**City of Lockhart
Planning and Zoning Commission
7:00 PM, Wednesday, November 12, 2025
Municipal Building – Glosserman Room
308 W. San Antonio St.**

PLANNING DEPARTMENT REPORT

STAFF CONTACT: David Fowler, AICP, Planning Director CASE NUMBER: ZC-25-06 and PDD-25-01
REPORT DATE: November 6, 2025
PLANNING & ZONING COMMISSION DATE: November 12, 2025
CITY COUNCIL DATE: December 2, 2025
STAFF RECOMMENDATION: ***Approval, at the discretion of the Commissioners***
SUGGESTED CONDITIONS: None

Seawillow Ranch Phase One Planned Development District

Exhibit B - Development Plan

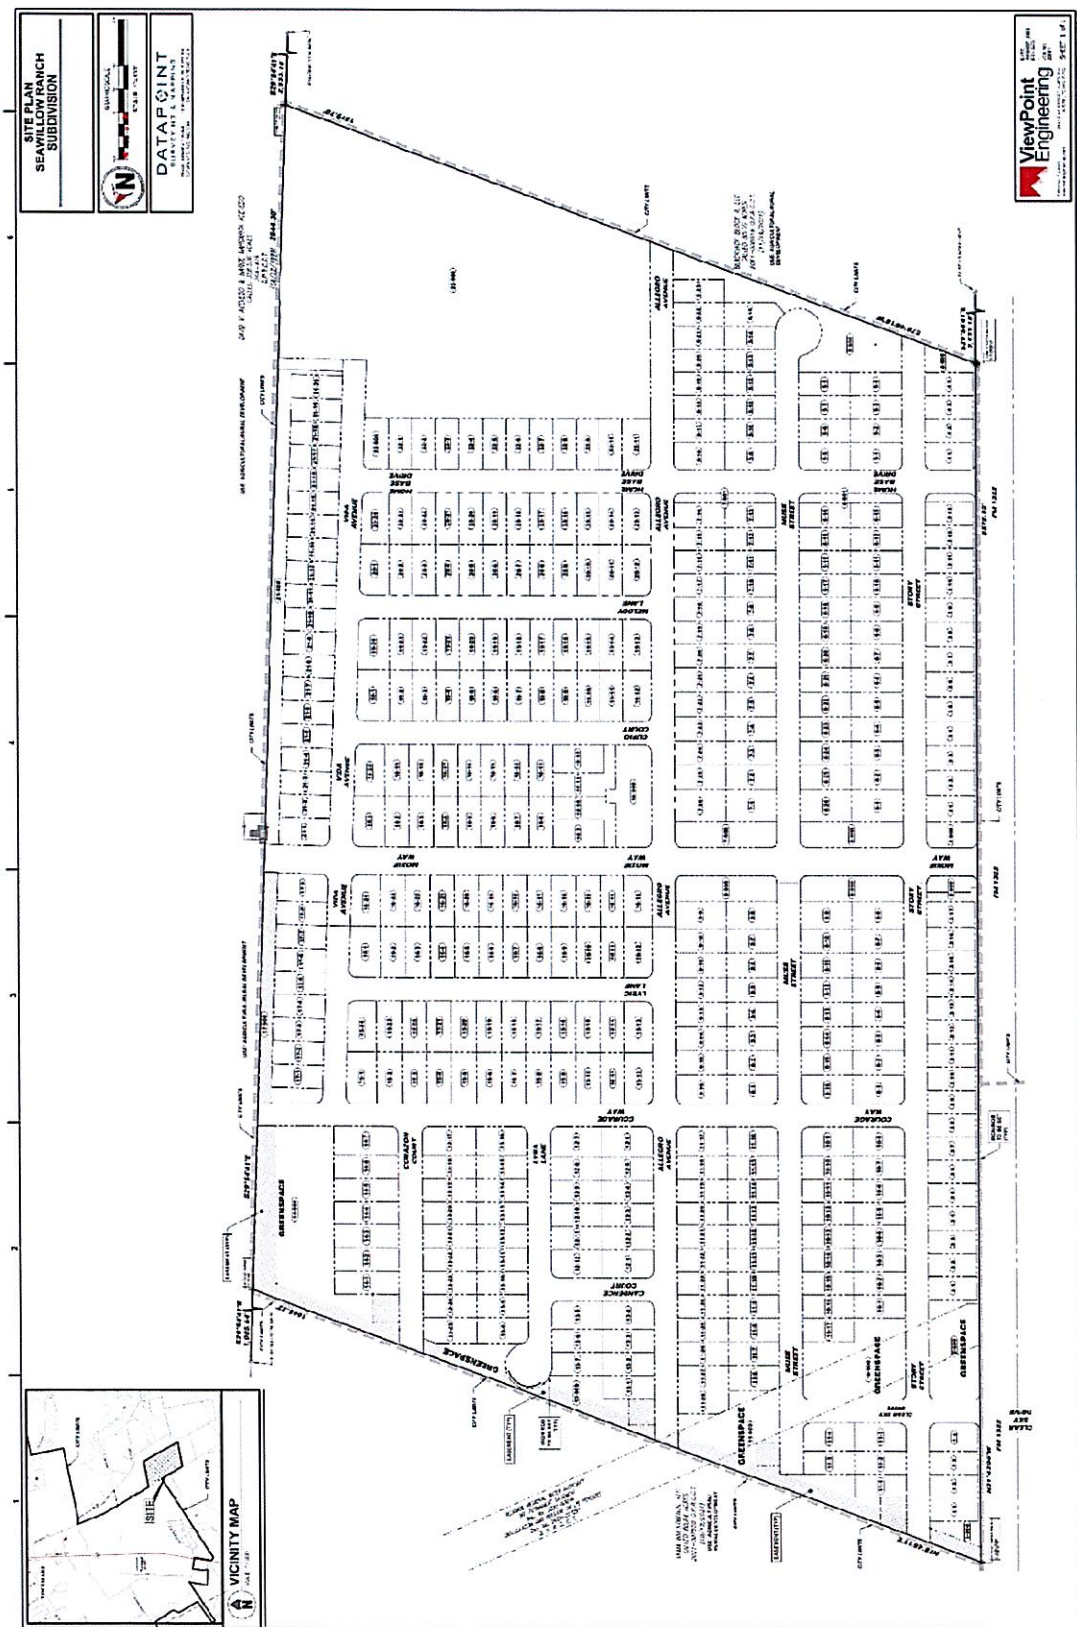
The proposed development is 89.775 acres with 390 total lots. Circulation would be provided through a series of roads within the subdivision. External access will be provided by two street connections to FM 1322, with two stubs provided to the east to access future phases of areas within the Seawillow Development agreement and two stubs to south to connect to the recently approved Sendero preliminary plat area.

In terms of the second main change requested in the PDD, Section E. details that in addition to the allowed uses within the RMD zoning district, the PDD would allow portable food establishments and eating establishments of any type, including sales of alcoholic beverages, within the park area located near Moxie Way and Allegro Avenue. Related to this change in allowed uses, no off-street parking would be required for any of the so-called accessory retail uses under 2,000 square feet. As is stated in Section F.5., these uses will not require off-street parking, instead relying on foot traffic and on-street parking.

One additional concern is that the addition of food sales, possibly including sales of alcohol, in the park area could create issues of noise, traffic, lack of parking, and littering if the food facilities attract significant visitors from outside the immediate vicinity. It should be noted that the area labeled "activated park space" in Exhibit C is only slightly larger than two corner residential lots within the subdivision plat, which could create potential nuisances for abutting and nearby residential properties. For these reasons, staff does not necessarily recommend denial but does not strongly recommend approval either.

Exhibit D - Deep Setback Garage Lot Design Exhibit

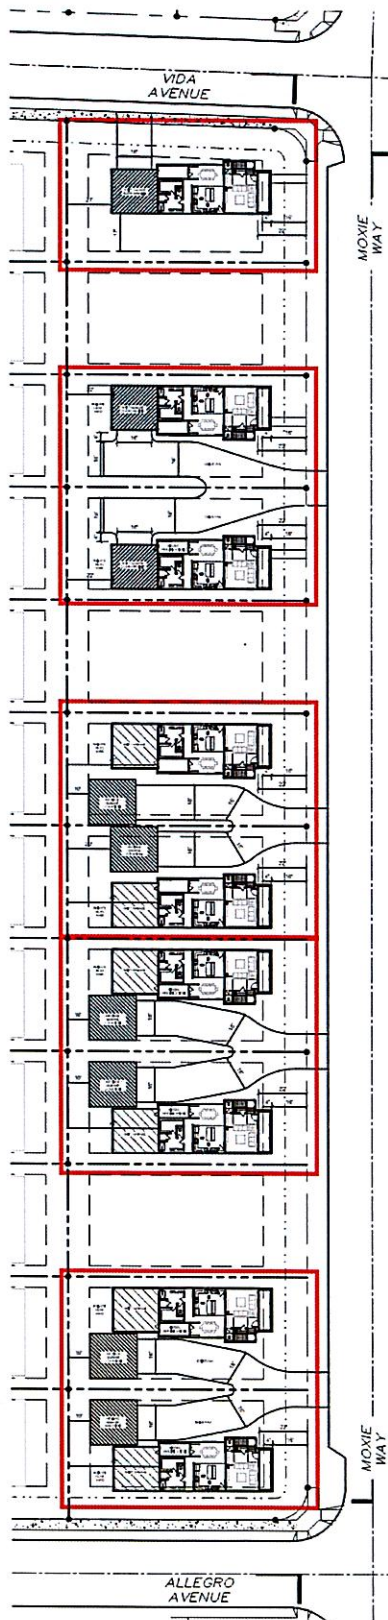
Setback Garage Lots,” which is proposed to apply to 24 lots, the PDD proposes reduced side and rear setbacks for garages. These lots, which are designed around driveways shared by two lots, would allow five-foot rear setbacks and zero-foot side setbacks for rear detached garages. The standard 10-foot rear setback and five-foot side setbacks would apply for all other structures, such as houses, sheds and accessory dwelling units. The revised lot standards, and a comparison to the standard SF-2 lot requirements, can be found in Section G of the PDD plan, and is reproduced below:
